**AMENDMENTS TO THE DRAWINGS**

### **REMARKS**

FIG. 2

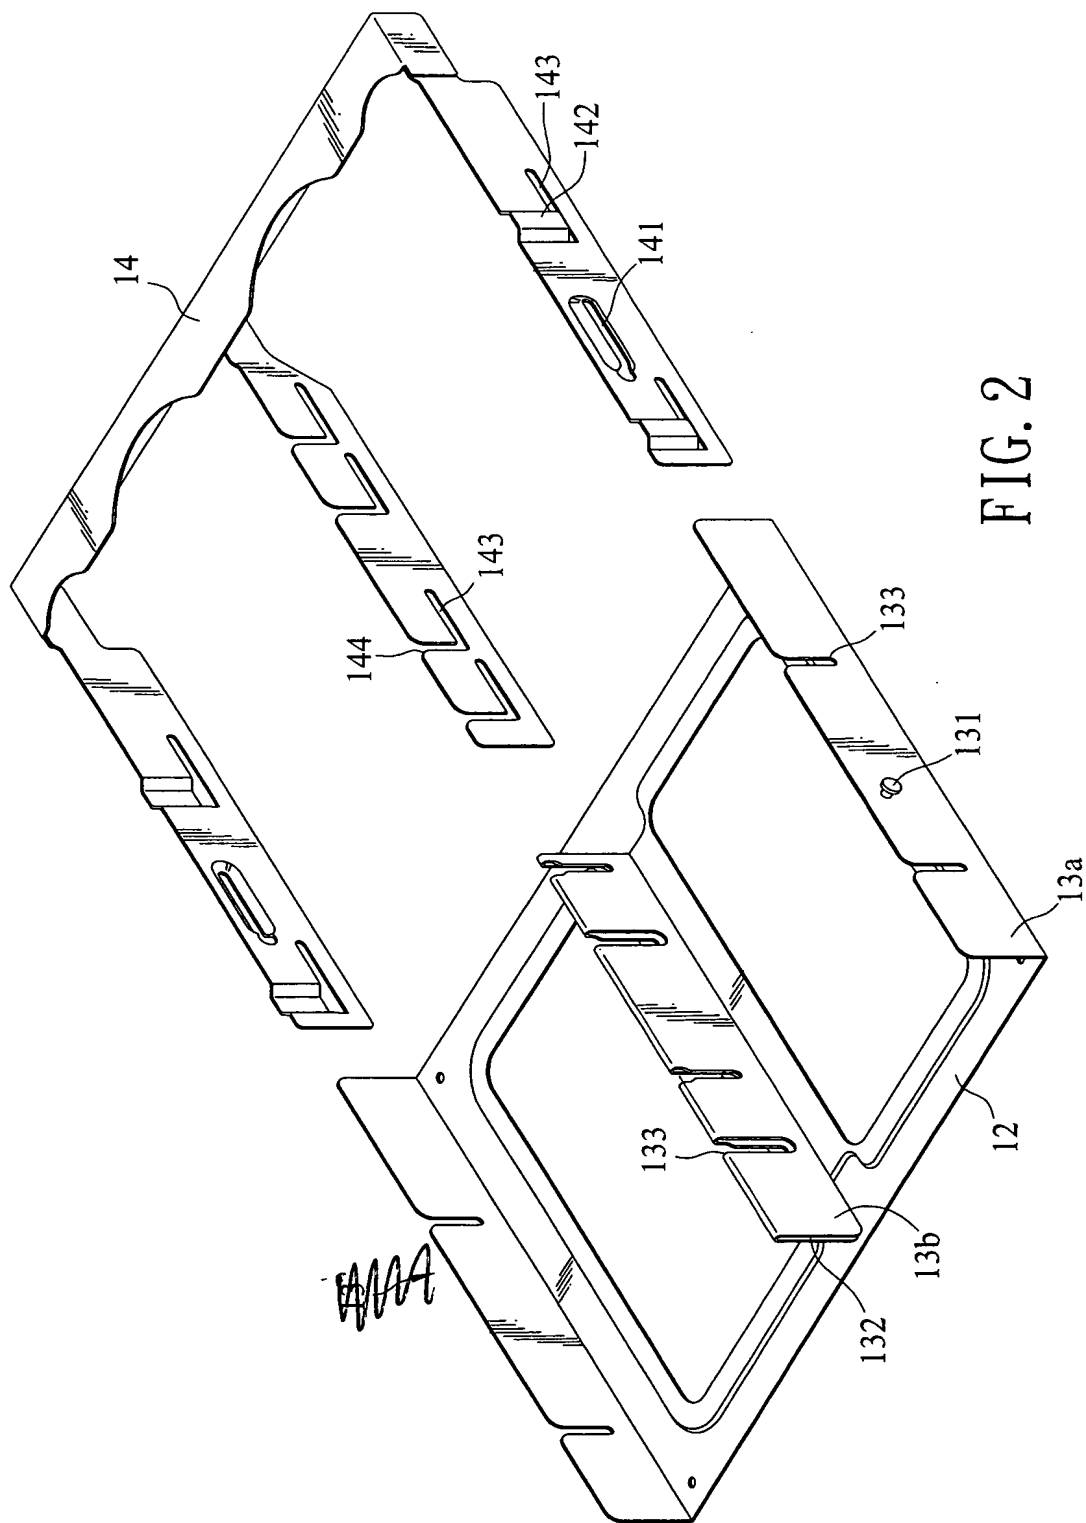
Fig. 2 has been amended to remove reference numeral 13 and its associated lead line; and

The Examiner objected to the drawings as failing to comply with the rules because they include reference numeral 13 which is not included in the specification. By way of the present amendment, Fig. 2 has been corrected to remove reference numeral 13. The Examiner also objected to the drawings as having reference numeral 141 in Fig. 6A, which refers to a different portion than that found in the other figures. By way of the present amendment, Applicants are submitting replacement Fig. 6A, which removes the incorrect reference numeral 141. As required by the Examiner, a marked-up version of the drawings, showing the changes made, is also provided.

FIG. 6A

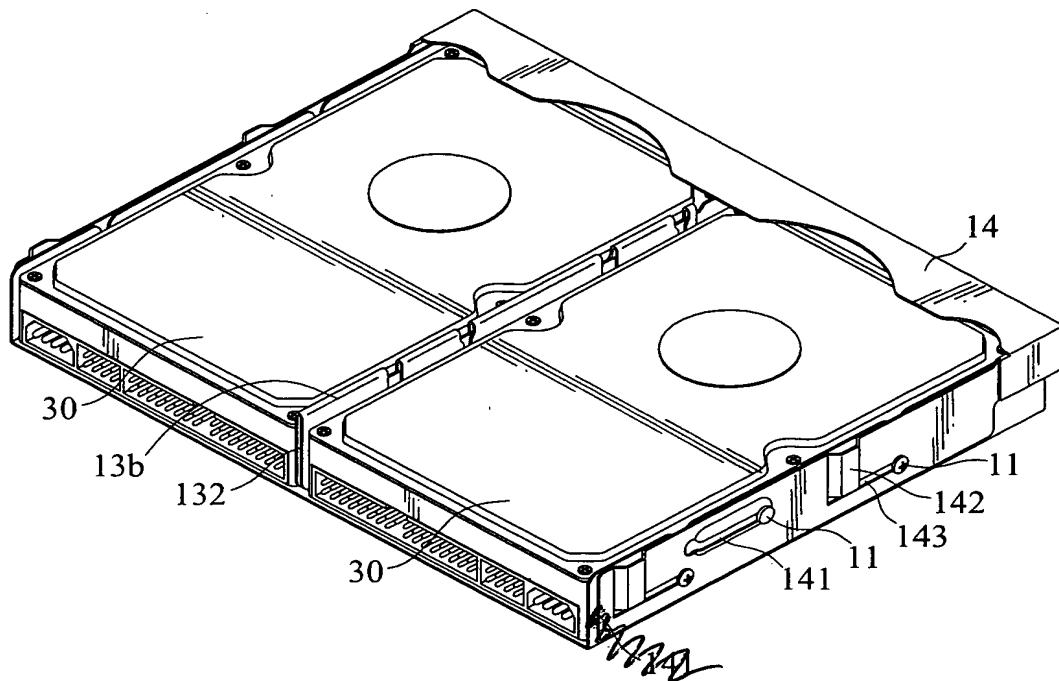
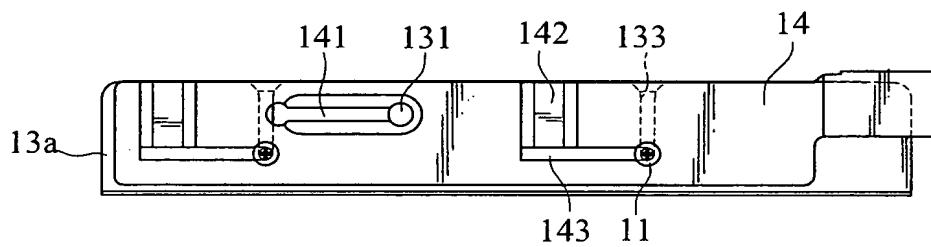
Fig. 6 has been amended to remove one occurrence of reference numeral 141 and its associated lead line.
